17 October 2023

Request for further information in accordance with section 92 of the Resource Management Act 1991

- Eastern Busway EB3C
 - BUN60423907 (Council Reference)
 - CST60423908 (vegetation removal), CST60423955 (planting),
 - CST60423956 (reclamation), CST60423957 (structure),
 - DIS60423909 (contaminated site), DIS60423958 (stormwater),
 - WAT60423930 (groundwater), LUC60423931 (land use),
 - LUS60423990 (streamworks)

- Eastern Busway EB4L
 - BUN60423878 (Council Reference)
 - DIS60423878 (contaminated site), LUC60423920 (land use),
 - LUS60423921 (streamworks)

Figure 6-1 Extent of works near R11/1263 Donnelly's Quarry.

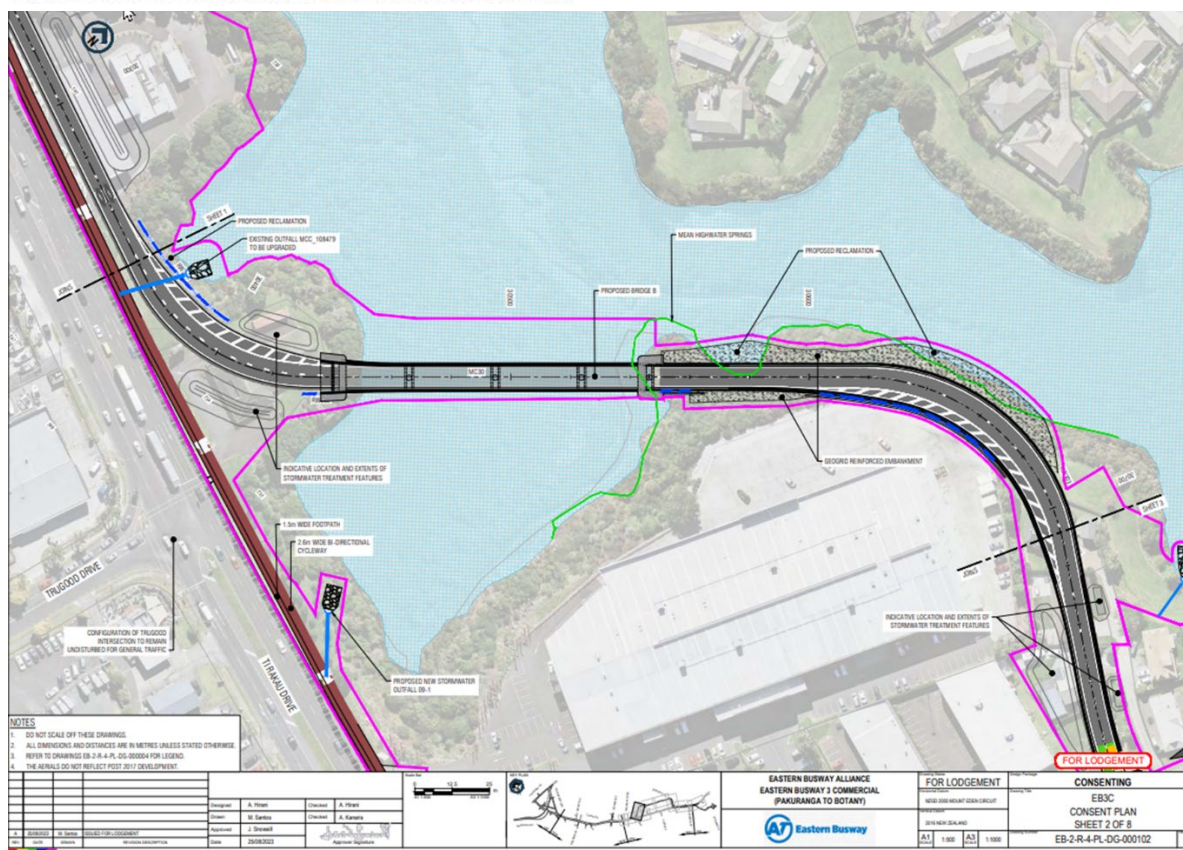
Please note that Council will recommend that the removal of all vegetation occurs in the first instance to enable thorough detailed recording as there is disagreement with the statement made on p32:

Furthermore, the highlighted portions of the above statement appear at odds with the following plans, where: General arrangement (App 7) EB-2-R-4-PL-DG-000102 Revision A (overleaf) shows the bridge going through the middle of the scheduled site as does Figure 6-1 Extent of works near R11/1263 Donnelly's Quarry on page 35 of the Archaeological assessment.

- (5) To confirm the potential archaeological effects on the quarry, and having discussed with Ms Eaves a design that avoids the features of Donnelly Quarry as set out in Figure 4-4 of the Archaeological Assessment including the Quarry Face, please provide the revised plans to this effect.

Figure 6-1 Extent of works near R11/1263 Donnelly's Quarry.

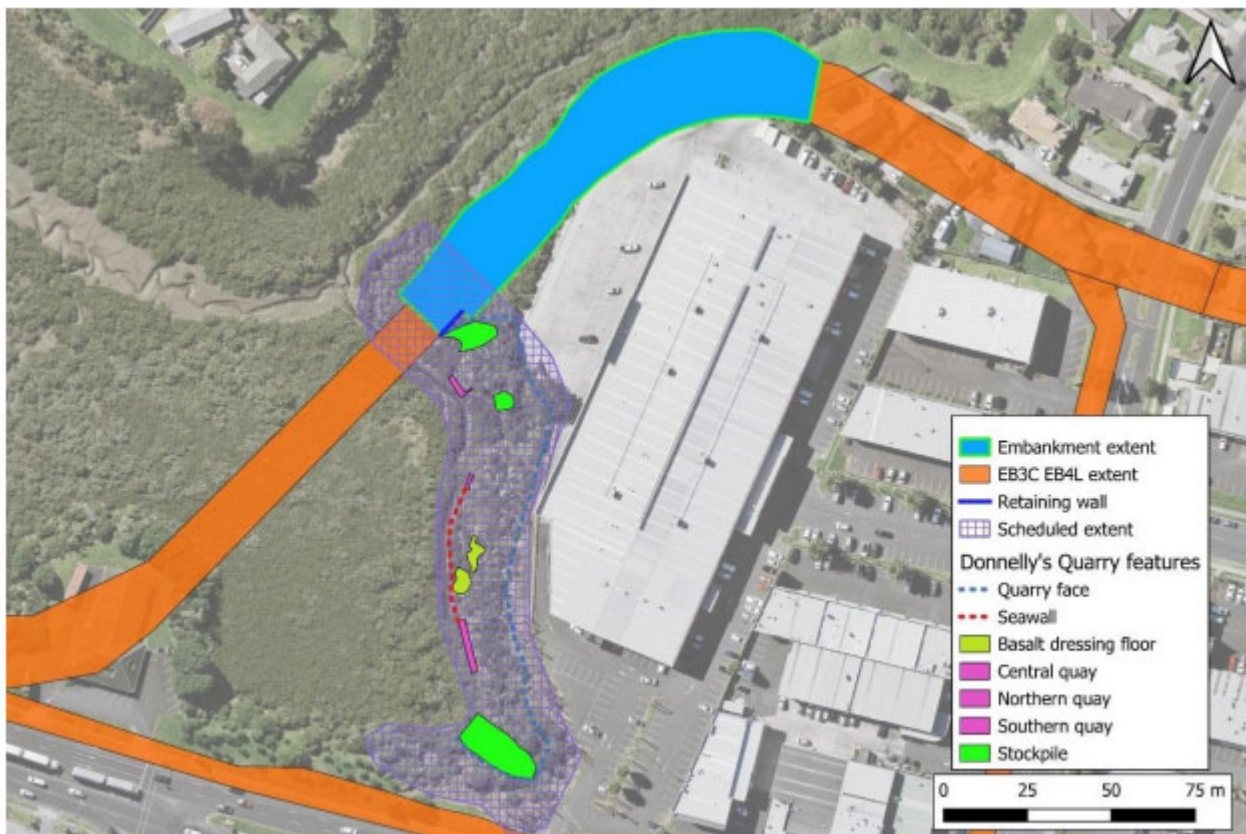
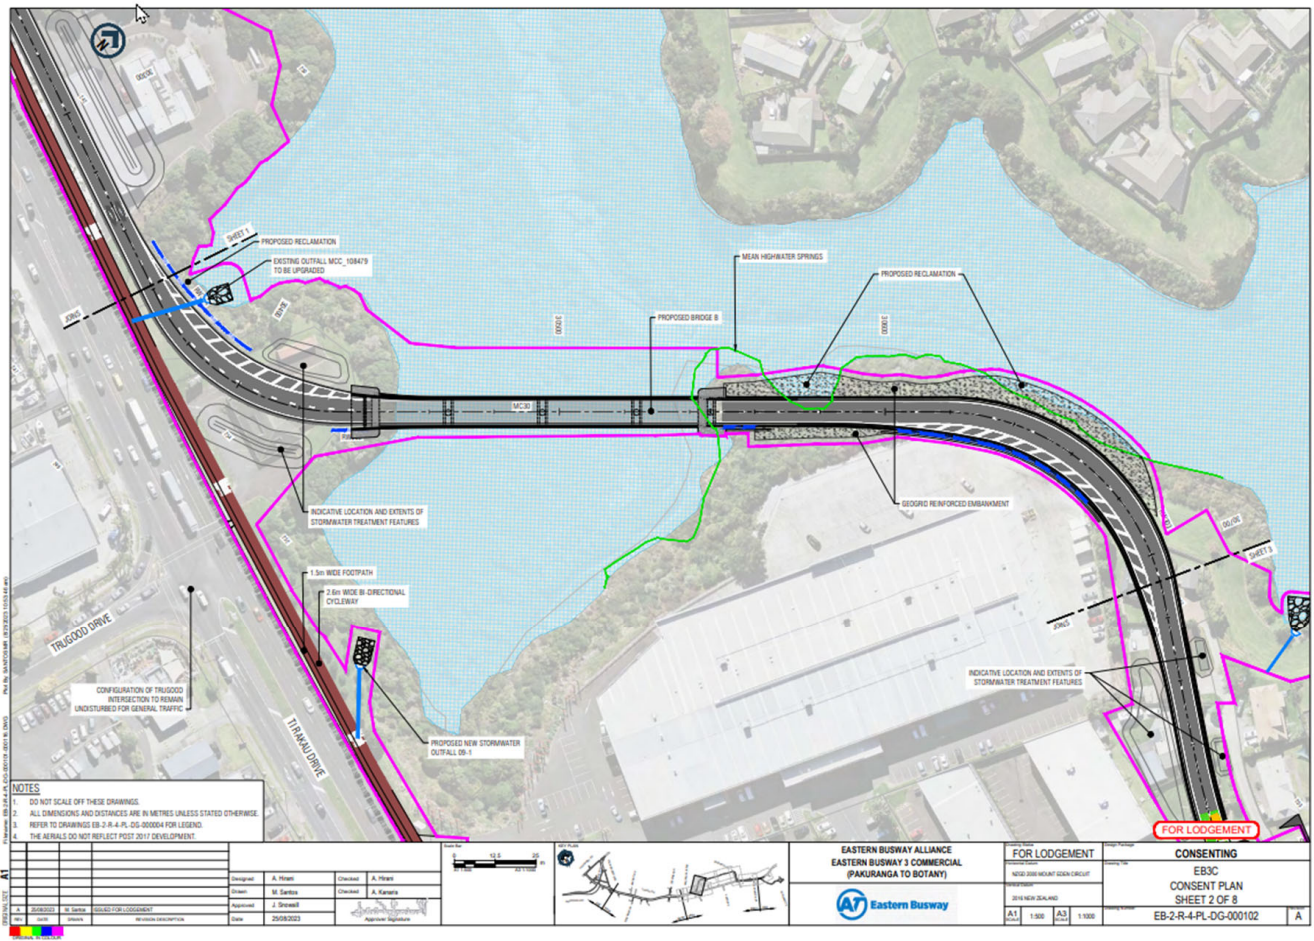
It is desirable to remove all vegetation first to enable thorough detailed recording as I do not agree with the statement made on p32:

These highlighted portions seem to be out of kilter with all other table of contents figures etc although that could be me. General arrangement (App 7) EB-2-R-4-PL-DG-000102 A shows the bridge going through the middle of the scheduled site, so I request a set of plans that provide clear evidence of the revised design. [Note that I appreciate the *discussed* revision, I would just like to see the plans please]. This is because the documents I have show: from page 35 (Arch As) and

in the AEE BUN60423907 app8 General Arrangement

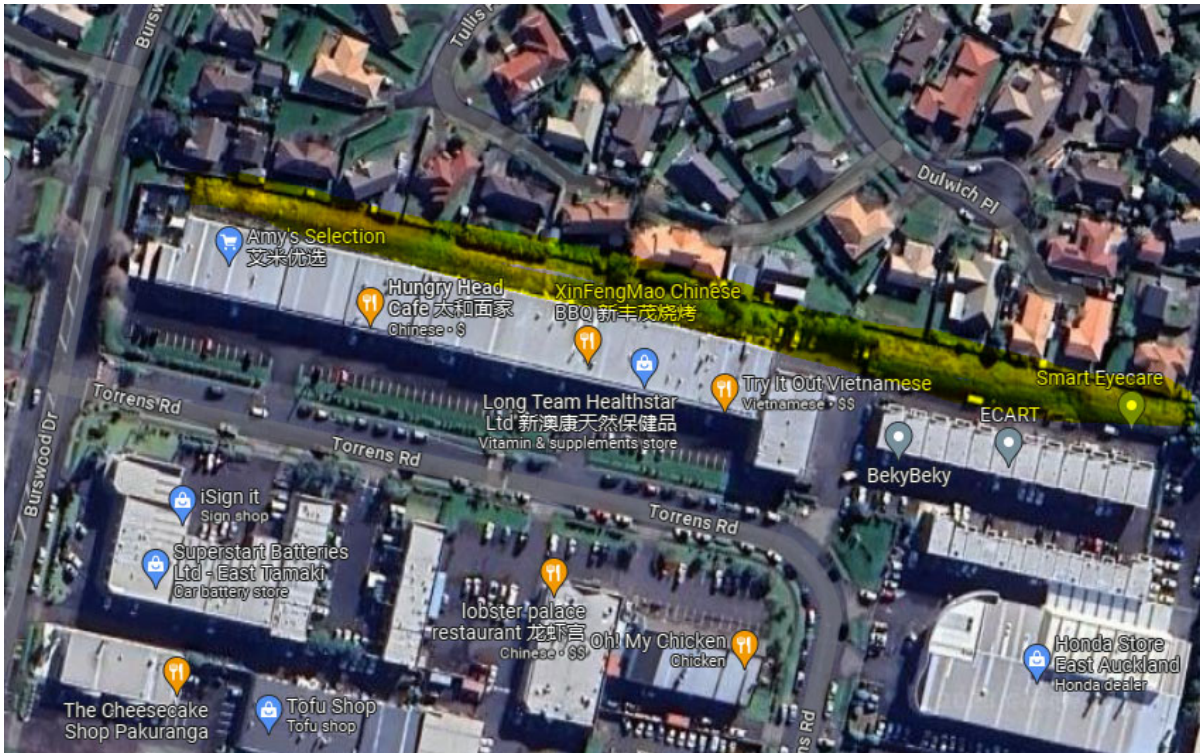
In addition to the HAIL sites listed in contaminated land report, during the site visit, a large soil stockpiled bund was observed at the rear of the businesses on Torrens Rd, Burswood. The material was understood to contain soil/construction waste material left over from the developers of this commercial precinct (shown highlighted in yellow

in the image below) This stockpiled bund, was identified as an area of potential contamination concern and an area that may need to be disturbed during the bus station works proposed in this area.

I suggest if this material is to be disturbed as part of the Project the material is tested before any works commence. Further I recommend this location be added as a potential 'HAIL' site within the EB3C alignment.

Figure 46: Indicative layout of the CSA and SAPs at the Burswood Esplanade Reserve in EB3C

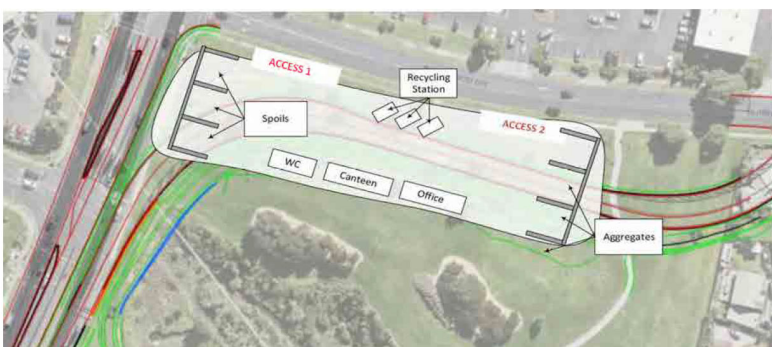
Figure 46 from the ITA report identifies the location of a Construction Support Area (CSA) within Burswood Esplanade, where the applicant has stated that Construction Support Areas (CSA, CSA1, CSA2) and Site Access Points (SAP's) will be mitigated for stormwater runoff, without any details.

(28) In the absence of a CEMP as part of the application, please advise how stormwater will be managed

Figure 46 shows the location of the CSA and SAPs at the Burswood Esplanade Reserve in EB3C.

The applicant stated that Construction Support Areas (CSA, CSA1, CSA2) and Site Access Points (SAP's) will be mitigated for stormwater runoff, without any details.
